Planning Inspectorate Reference: EN010098  
MMO Reference: DCO/2018/00014  
Identification Number: 20029896

**Planning Act 2008 - Application by Ørsted Hornsea Project Four (UK) Limited (“Ltd”) for an Order Granting Development Consent for Hornsea Project Four Offshore Wind Farm**

**Deadline 6 Submission**

**Figure 1** - Sediment transport vectors based on a Rare Earth elements tracer study based on the applicant Figure EX1 (Pye, Blott, Pye, 2015).

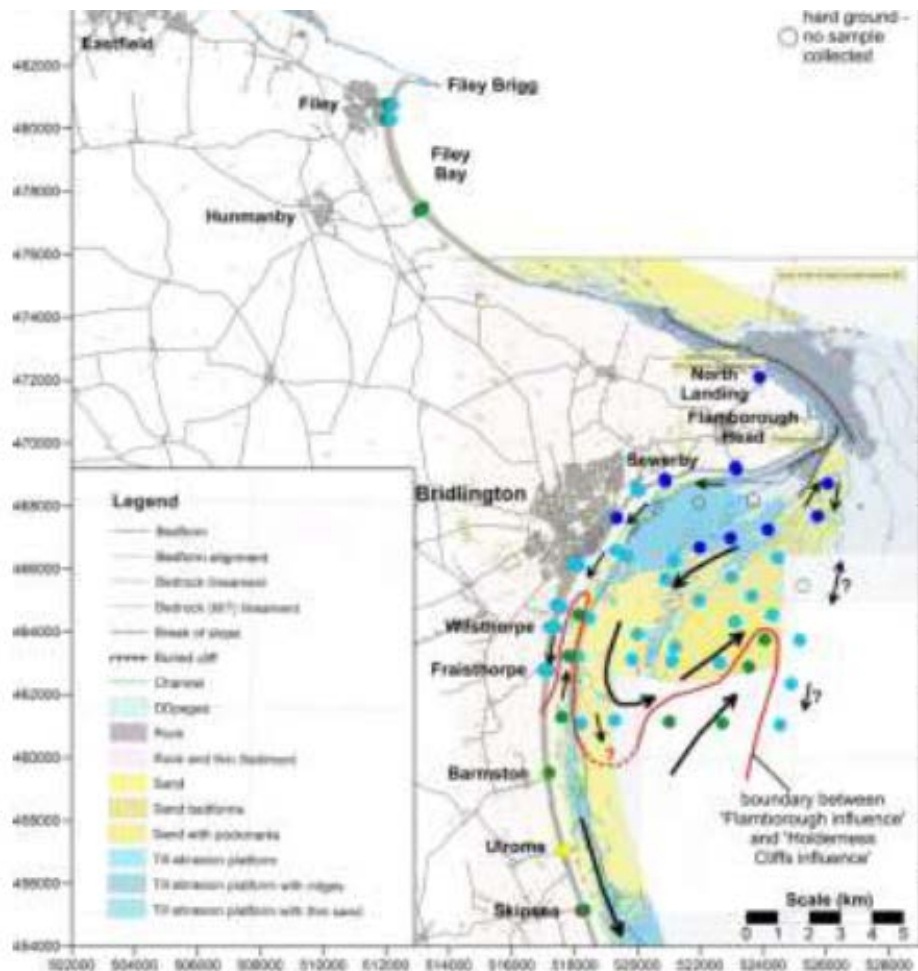
2.5.3 In section 2.5.1.5 Professor Elliot considers the mechanism for the formation of Smithic Bank. It should be noted that we consider the whole of Flamborough Head, Smithic bank, Holderness to Spurn Point as a connected system. Whilst input from Flamborough are well documented, the status of Smithic Bank is still open to debate. The eastern sediment flow on northern tip of Smithic and the southward flow on the eastern side of the bank is well documented by numerous authors and from recent swath bathymetry campaigns. However, the authoritative geomorphologists Pye, Blott and Pye (2015) and shown in Figure 1 of this submission (below), using a tracer and concentration methodology show

an anti-clockwise circulation in the southern half of the Smithic Bank. Furthermore, the debate continues as to the function of Smithic Bank. Is it a “leaky reservoir” of sediment that episodically releases sediment onto the Holderness foreshore, is there a northern transport pathway close inshore (near Wilsthorpe) or does the Holderness coast itself contribute to Smithic Bank sands?

2.5.4 These sediments contribute to the Holderness Coast being transported south to Spurn Point. Therefore, in both terms of coastal protection of Bridlington and potential impacts on the Holderness Marine Conservation Zone we consider the whole of the system a “receptor”.

**Figure 2** – Dogger Bank AB Cable Crossing in Relation to Smithic Bank (from REP5a-017)

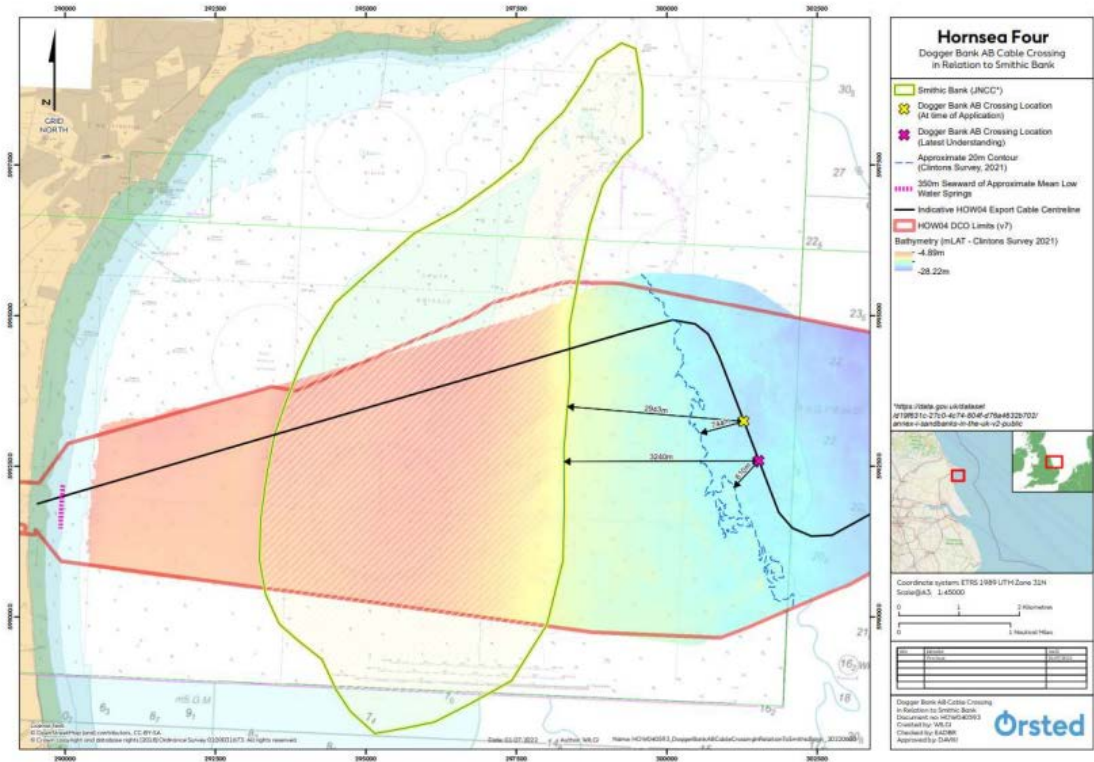
- 2.6.2 In Figure 2 of this submission (from REP5a-017), the Swath bathymetry and export cable route for the Hornsea Project Four are plotted along with Joint Nature Conservation Committee (JNCC) shape file of Smithic Bank. We propose that this “lozenge” shaped area be the basis of the pre-conditioned swath bathymetry monitoring survey, subsequently when the actual laid routes of Dogger Bank A&B as well as Hornsea Project Four are determined then an export cable corridor (ECC) survey plan can be considered (the Scotland England Green Link 2 may also be nearer construction if approved). Only once all these routes are finalised can the ECC survey plan be agreed. It is noted that consideration of holistic swath bathymetry monitoring plan between the three developers may produce scientific more robust data and also save resources.

**Figure 3** – MDS ordination of infaunal data along the Export Cable Corridor (ECC) of Hornsea Four OWF (from Hornsea Four ES Vol A5, Annex 2.1: Benthic and Intertidal Ecology Technical Report (AS-009))

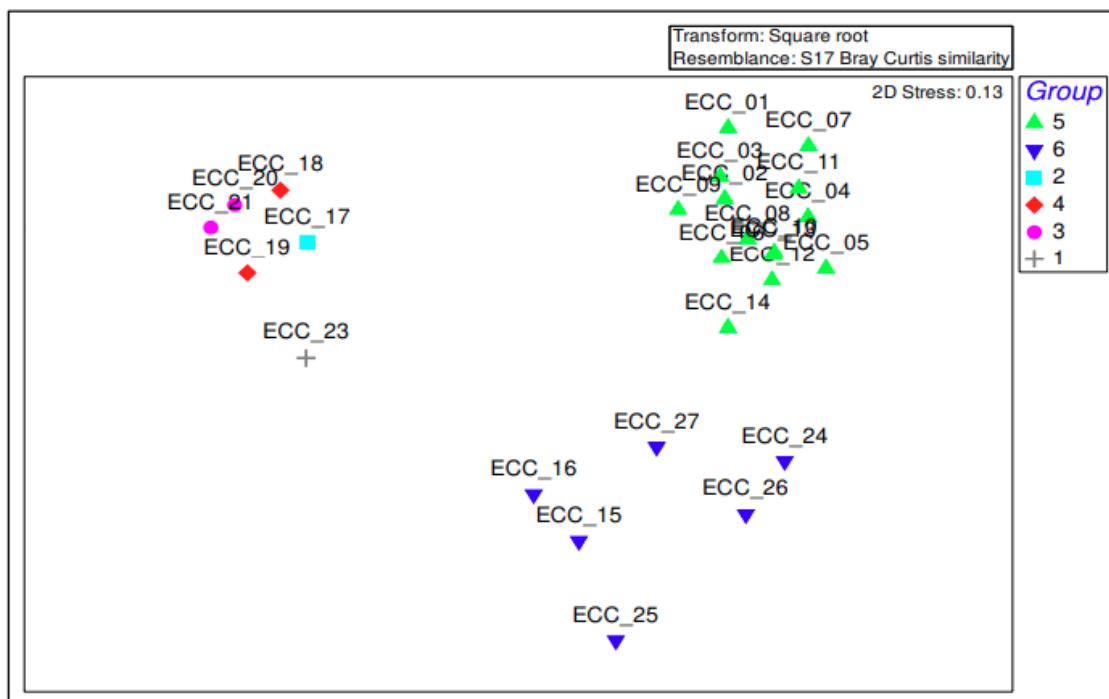
<p>3.4.28: It is not clear from the text in the reports whether an unbiased statistical accuracy assessment has been undertaken. The models use a combination of computational analysis and expert judgement; however, it would be beneficial to have a confidence element to the models due to the poor match, in some cases, to the physical data</p>	<p>As noted in <a href="#">Volume A5, Annex 2.1: Benthic and Intertidal Ecology Technical Report (APP-068)</a>, confidence scores were assigned to all polygons to give an indication of their accuracy.</p>	<p>The MMO notes the Applicants response, however this appears to be related to the Annex I stony reef assessment undertaken by OceanEcology. There does not appear to be a similar confidence assessment of the predictive models. This should be considered in the future if predictive models are used.</p>
<p>3.4.29: <i>S. spinulosa</i> was identified at stations ECC17-21 in high numbers being the dominant species at these stations, however the biotope assigned did not include <i>S. spinulosa</i> as a characterising species and therefore does not reflect the faunal composition of those stations. Whilst the species was identified in high numbers, no reef was identified in the grab samples. However, the presence of this species and dominance at these stations should be mentioned in the ES chapter. It is not clear whether the geophysical data was interrogated at the stations to determine whether any reef signatures were apparent. The MMO</p>	<p>The presence of this species and dominance at these stations is recorded with <a href="#">Volume A5, Annex 2.1: Benthic and Intertidal Ecology Technical Report (APP-068)</a>. Furthermore, the numbers of <i>S. spinulosa</i> identified within the surveys is not considered high enough to quantify as an Annex I reef habitat or a Sabellaria reef biotope. Moreover, as detailed in Section 1.2 of Appendix A, <a href="#">Volume A5, Annex 2.1: Benthic and Intertidal Ecology Technical Report (APP-068)</a>, grab samples targeted the range of different sediments and depths observed in the geophysical study. The Applicant will conduct biogenic and geogenic reef surveys as part of pre-construction survey efforts, to identify any biogenic reef features and to enable micro-siting around such features, if present</p>	<p>The MMO notes the Applicants response that the presence of this species is noted in the Benthic Technical Report (A5), however this information has not been translated to the ES Benthic Chapter (A2). Whilst the evidence provided (grab, DDV and acoustic) does not point towards the presence of reef, the presence of this species in high abundances should be mentioned in the main ES Benthic chapter (A2). We appreciate the inclusion of a pre-construction survey to identify any biogenic features for micro-siting and recommend EEC_17 to EEC_21 to be included in this survey.</p>

<p>requires clarification on this matter.</p>		
<p>3.4.30: A number of embedded mitigation commitments have been detailed in the commitments register and in Table 2.12 of Chapter 2 which are appropriate. There are two commitments (Co48 and Co84) to avoid any habitats of principle importance under the NERC Act 2006. The location of these will be informed through pre-construction surveys including micro siting where possible. The absence of <i>S. spinulosa</i> reef from the locations identified as containing high abundances of the species must therefore be confirmed.</p>	<p>The Applicant can confirm that in line with Co84 (<a href="#">Volume A4, Annex 5.2: Commitments Register (APP-050)</a>), foundations and cables will be micro-sited around habitats of principal importance wherever reasonably practicable (subject to agreement with the MMO). Additionally (and also in line with Co84), benthic monitoring will be undertaken at pre-construction phase of the proposed development in order to determine the location, extent and composition of any habitats of principal importance (Section 41 of the 2006 Natural Environmental and Rural Communities (NERC) Act). In the event that habitats of principal importance are identified in the pre-construction survey; post-construction monitoring will also be carried out with a focus on these identified habitats.</p>	<p>The MMO notes the Applicants response and appreciate the inclusion of a pre-construction survey to identify habitats of principle importance under section 41 of the NERC 2006 Act. The MMO encourages the inclusion of EEC_17 to EEC_21 within this survey.</p>
